**City of Cascade
City Council Public Hearing
Staff Report
The River District
Annex 19-01, Zone 19-01, PUC 19-01, SUB 19-01**

Staff: Heather M. Soelberg
Public Hearing: November 18, 2019
Applicant: Steve Arnold, A-Team Land Development & Real Estate
Owner: Cascade River LLC
Location: North-east of Highway 55, adjacent to the Payette River
Size of Site: 122.41 acres (updated)
Existing Zone: Mixed Use (MU)
Proposed Use: Mixed Use Subdivision

THE RIVER DISTRICT
PRELIMINARY PLAT/PUD MAP
LOCATED IN A PORTION OF SECTION 31
TOWNSHIP 14 N., RANGE 4 E., B.M.
VALLEY COUNTY, IDAHO

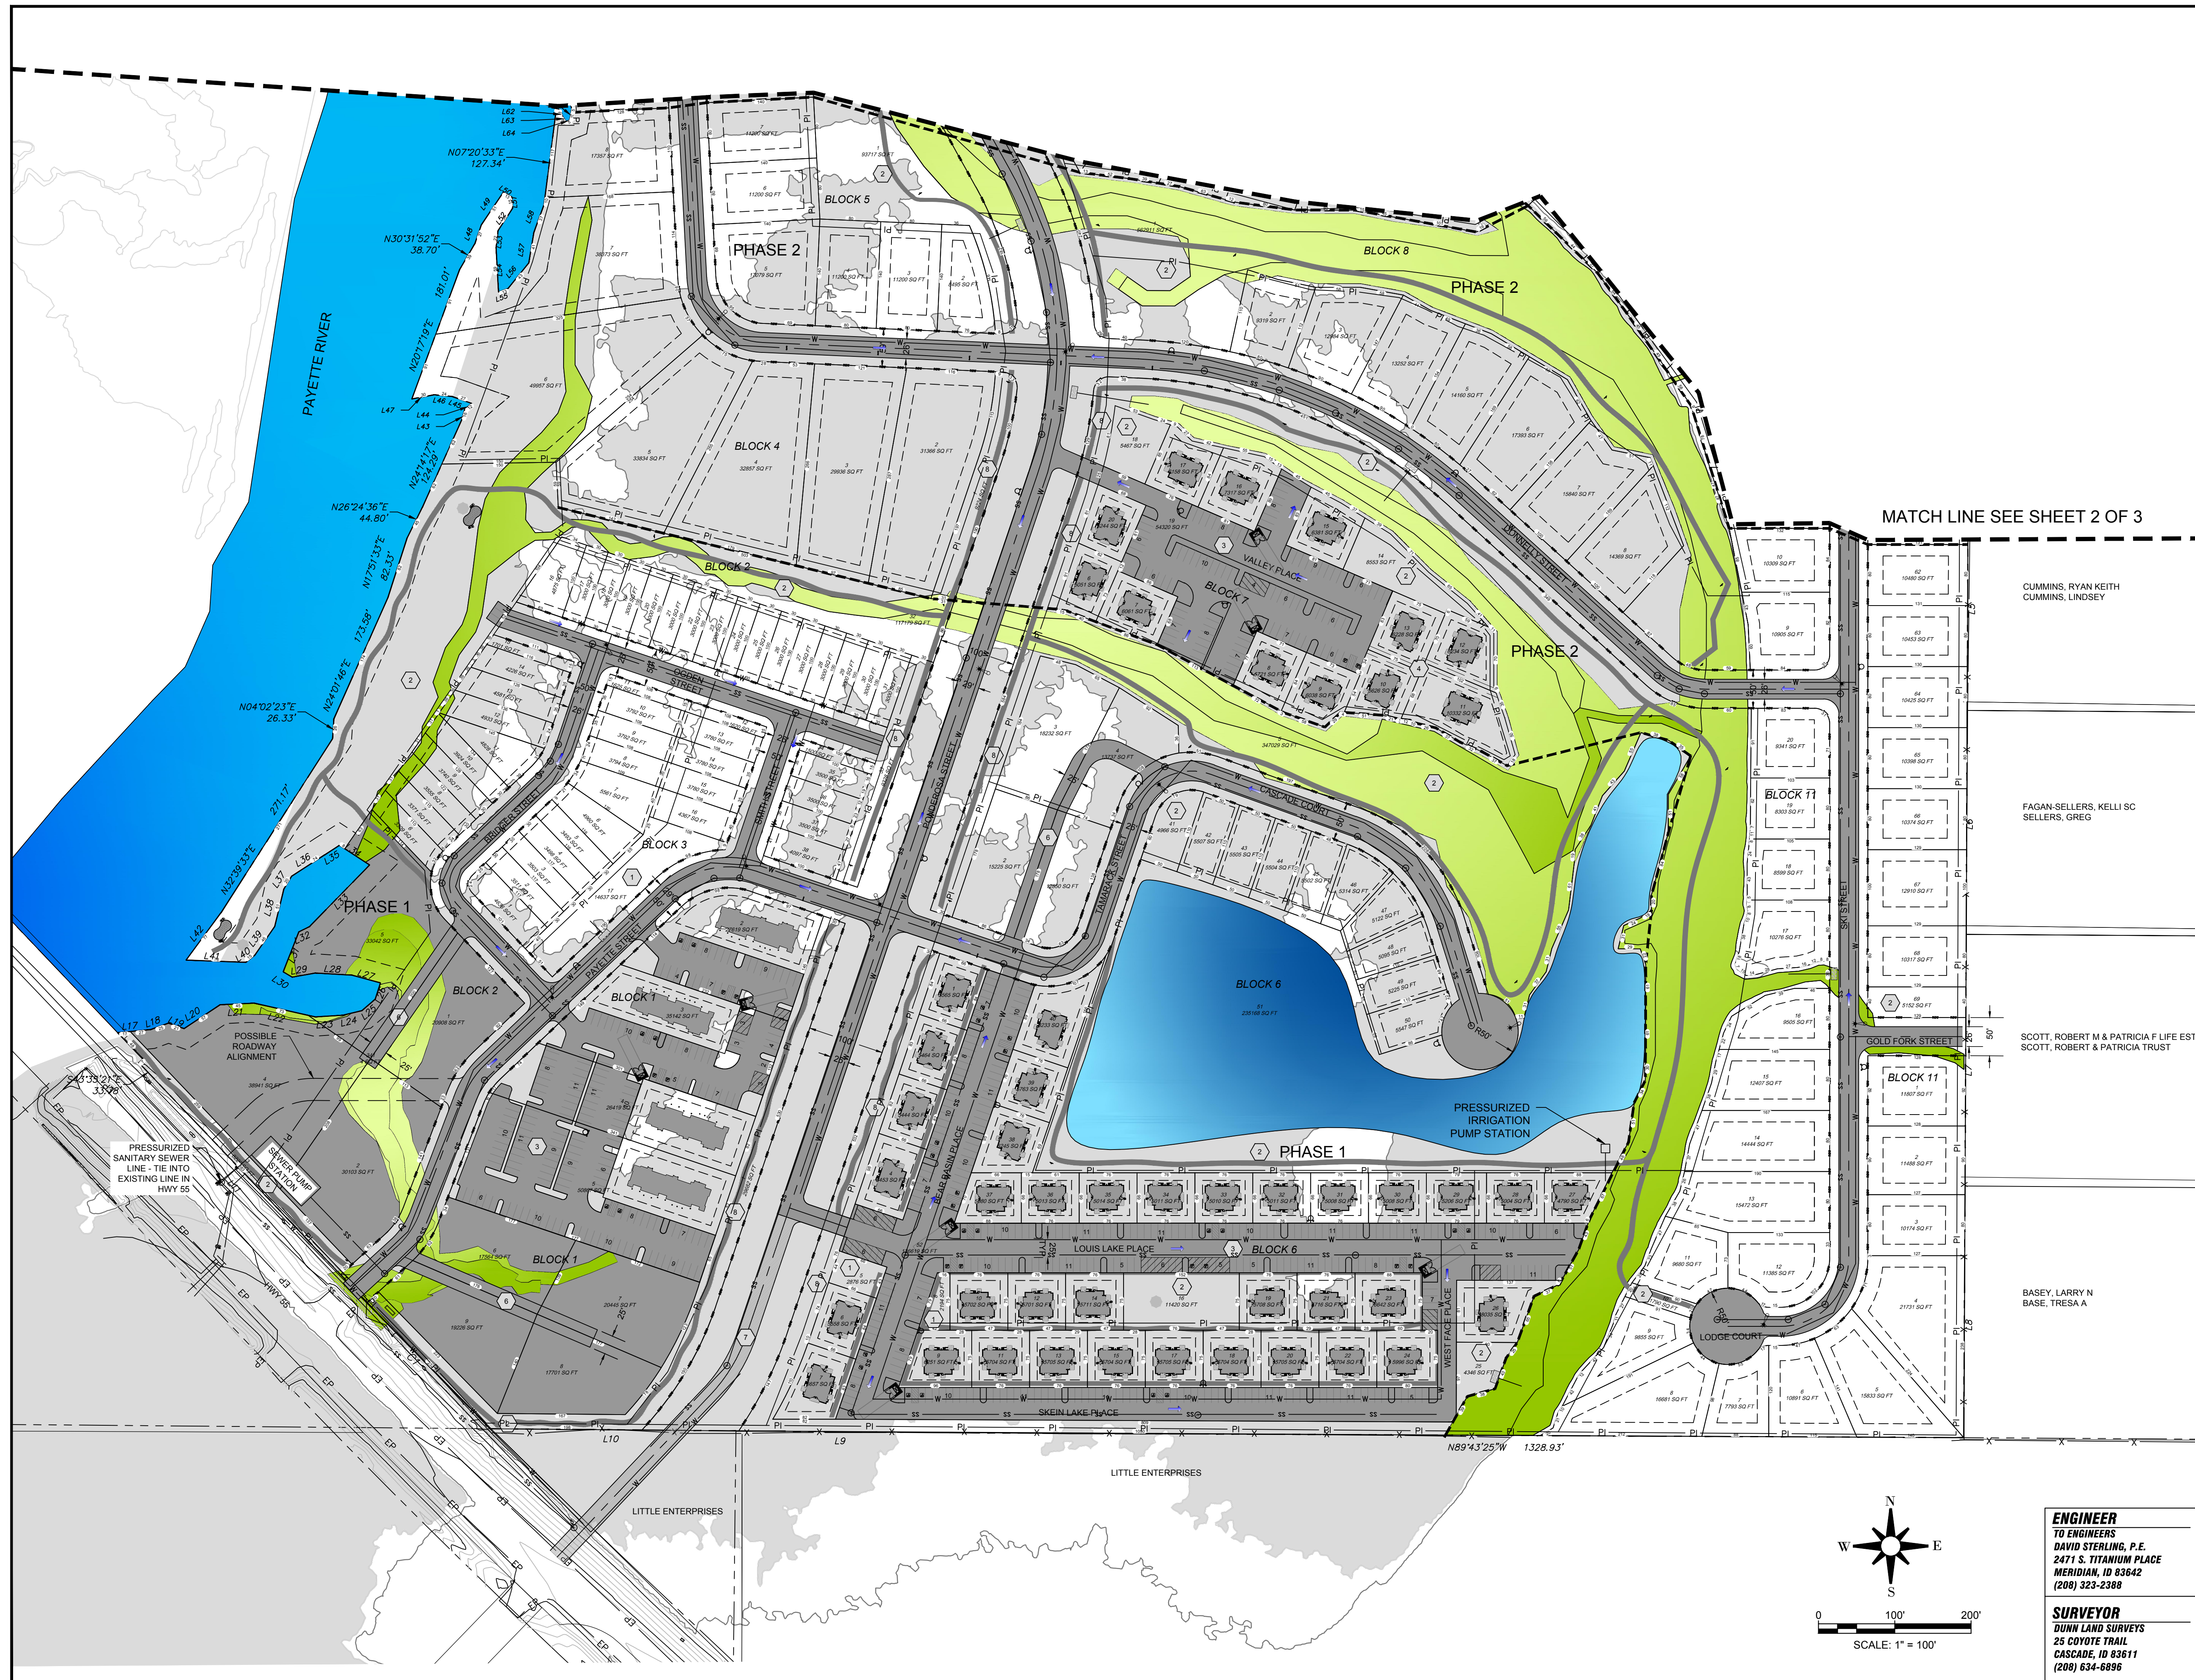
- a. **Show dimensions and radii at all corners, turns, approaches, accesses and cul-de-sacs.** *"Updated Preliminary Plat showing these revisions will be required no later than the Wednesday immediately prior to the City Council Hearing date in order to be included in the Council Packet."*

- b. **Show all easements, existing and proposed, within and at the boundary of the site to be shown.** *"Updated Preliminary Plat showing these revisions will be required no later than the Wednesday immediately prior to the City Council Hearing date in order to be included in the Council Packet."*

- c. **Survey data utilized to design the PUD and Preliminary Plat; Staff was concerned that survey data utilized was outdated which creates a risk to the City. Staff wanted City Engineer to review.** *Survey data utilized was NOT provided after several requests; rather new surveys were completed which showed that the Preliminary Plat as originally submitted had the wrong boundaries. After receipt of the [correct] legal description and modified survey, applicant sent updated Preliminary Plat with updated boundaries.*

4. Show calculation points with bearings of distances in all wetland delineated areas and "no build zones" on Preliminary and Final Plats.
 - a. **Not provided.**

5. All water sources shall be depicted on Final Plat including new and existing well(s).
 - a. **Not provided.**
6. Applicant to provide legal descriptions for separate rezone areas (C Zone description and R3 Zone description). Recommend approval of this finding subject to the condition of submission and administrative verification of the legal descriptions describing the different zone boundaries.
